[Docket No. FAA-2024-0237; Project Identifier AD-2023-00491-R; Amendment 39-22853; AD 2024-19-11]

Airworthiness Directives; Robinson Helicopter Company Helicopters

Final rule.

The FAA is adopting a new airworthiness directive (AD) for all Robinson Helicopter Company Model R44 and R44 II helicopters. This AD was prompted by reports of a fractured clutch shaft forward yoke (yoke) on the main rotor (M/R) drive due to fatigue cracking. This AD requires visually inspecting a certain part-numbered flex plate assembly (flex plate) and certain part-numbered yokes, including each flex plate bolt, and depending on the inspection results, removing an affected part from service and replacing an affected part with an airworthy part. This AD also requires removing a certain part-numbered yoke from service after accumulating a certain number of hours time-in-service (TIS) or a certain number of years, or as an alternative to removing the part from service, performing a 10× or higher power magnification visual inspection and, if needed, a magnetic particle inspection. The FAA is issuing this AD to address the unsafe condition on these products.

Figure 1 to Paragraph (g)(1)(i)—Flex Plate Inspection

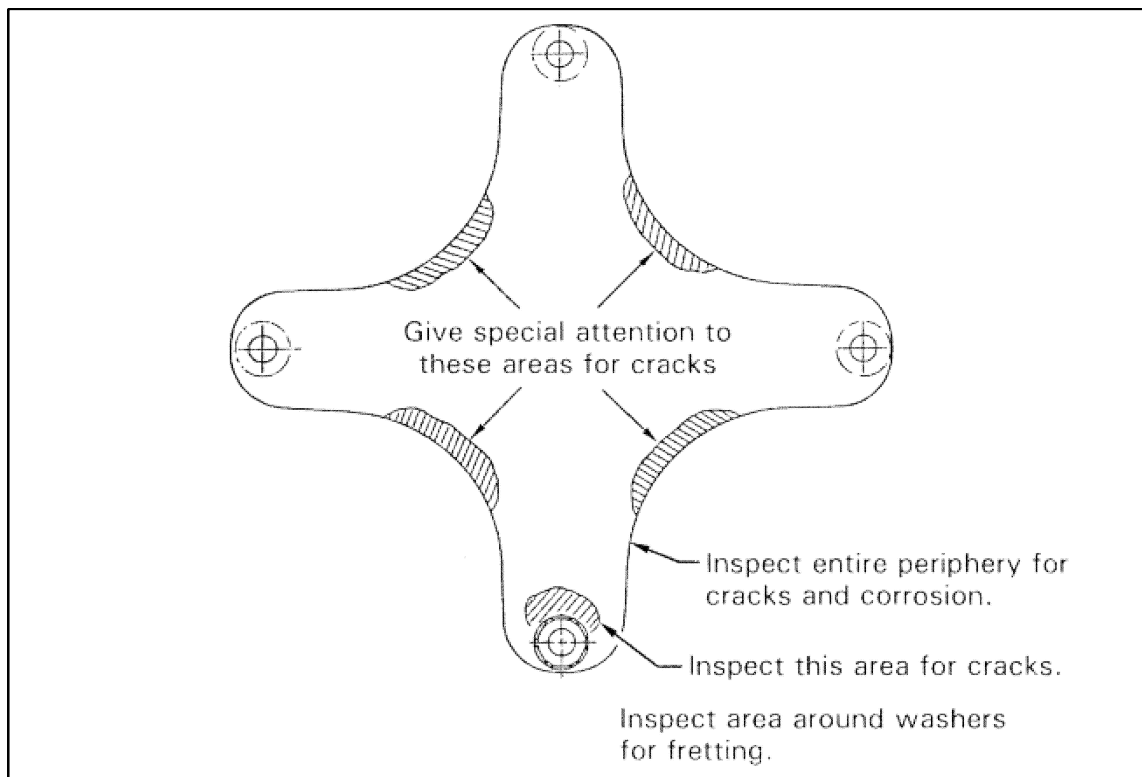
Request: Robinson Helicopter Company stated paragraph (g)(1)(iii) of the proposed AD requires ensuring that nut part number (P/N) D210-6 and palnut P/N B330-19 are installed. Robinson stated that per type design, only the two bolts on the flex plate assembly have palnut P/N B330-19 installed. Robinson Helicopter Company stated the wording in the proposed AD could cause some Model R44 helicopters to replace a yoke unnecessarily. Robinson Helicopter Company requested the FAA revise paragraph (g)(1)(iii) of the final rule to only apply to bolts shared with the flex plate assembly. Robinson Helicopter Company further stated it is possible some yokes do not have nut P/N D210-6 installed and would therefore also be subject to an unnecessary yoke replacement. Robinson Helicopter Company requested the FAA revise the wording of paragraph (g)(1)(iii) in the final rule to remove the reference to nut P/N D210-6.

FAA Response: The FAA agrees with these requests and revised paragraph (g)(1)(iii) of this AD to clarify that the inspection area is only for the flex plate assembly bolts and to remove any references to nut P/N D210-6.

(i) Visually inspect forward flex plate assembly (flex plate) part number (P/N) C947-1 for any loose fasteners, cracks, fretting, corrosion, wear, and to ensure that the washers are bonded to both sides of each flex plate arm, in the areas depicted in Figure 1 to paragraph (g)(1)(i) of this AD. If there is any loose fastener (can be moved by hand), crack, fretting, corrosion, or wear that consists of the washers not securely bonded to both sides of each flex plate arm, before further flight, remove the flex plate from service and replace with an airworthy flex plate.
